ADDENDUM No. 4

ITB No. 4424: W.R. Wheeler (Swift Run) Service Center PUD Non-motorized Improvements – Phase 1

**W.R. Wheeler (Swift Run) Service Center P.U.D.
Non-motorized Improvements - Phase 1 (ITB No. 4424)**

12' BOARDWALK FRAMING PLAN AND WALL APPROACH PLAN
NO SCALE

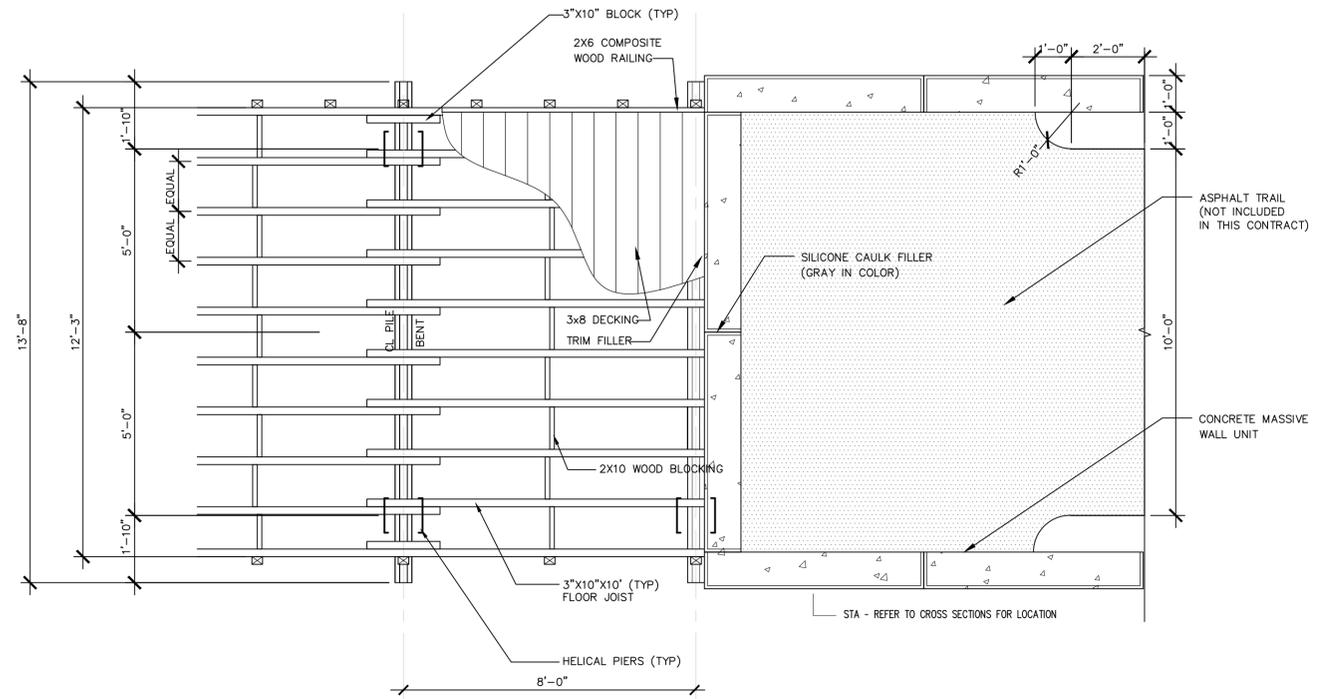
5. **Please clarify what the 3"x4" stanchions are on page 5, detail for "12' Boardwalk Framing Plan and Wall Approach Plan". These are not shown in the "Boardwalk Railing Detail".**
The stanchions shown the detail for "12' Boardwalk Framing Plan and Wall Approach Plan" do not apply and should not have been shown. The detail will be revised to accordingly. This plan revision will be addressed in Addendum No. 1.
